**Water Right Conditions
Tracking Slip**

FILE ## G-17119

PUBLIC INTEREST REVIEW FOR GROUND WATER APPLICATIONS

SUBJECT: Application G- 17119 Supersedes review of _____
Date of Review(s)

G 17119 NEARBY WATER LEVELS

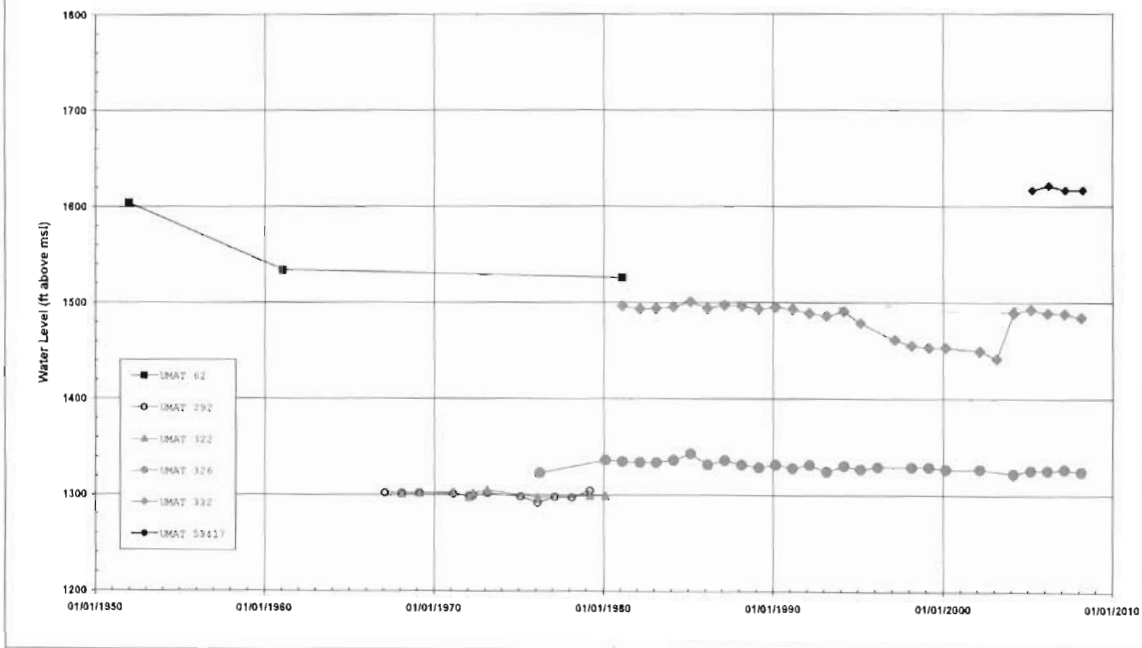
- B3. Ground water availability remarks: Currently measured basalt wells in the area are displaying reasonably stable water levels. Synoptic water levels at UMAT 332 during the late 1990s and early 2000s were not accurate as a result of a poor airline at the well. What is of greater concern with this application is that the proposal will likely result in substantial interference with a prior water right unless it is properly conditioned. The proposed well is only about 1900 feet from UMAT 331, which is authorized under Permit G-471. The proposed language below is recommended to ensure that the proposed well does not develop any water-bearing zones developed by UMAT 331, thereby minimizing the potential for substantial interference with this and other nearby senior rights.

The well shall be continuously cased and continuously sealed to a minimum depth of 675 feet below land surface. The well may not be completed in such a manner that it allows ground water to be developed from _____. If during well construction, it becomes apparent that the well can be constructed to eliminate interference with nearby shallow wells or hydraulically connected streams in a manner other than specified in this permit, the permittee can contact the Department Hydrogeologist for this permit or the Ground Water/Hydrology Section Manager to request approval of such construction. The request shall be in writing, and shall include a rough well log and a proposed construction design for approval by the Department. The request can be approved only if it is received and reviewed prior to placement of any permanent casing and sealing material. If the well is constructed first and then the request made, requested modification will not be approved. If approved, the new well depth and construction specifications will be incorporated into any certificate issued for this permit.
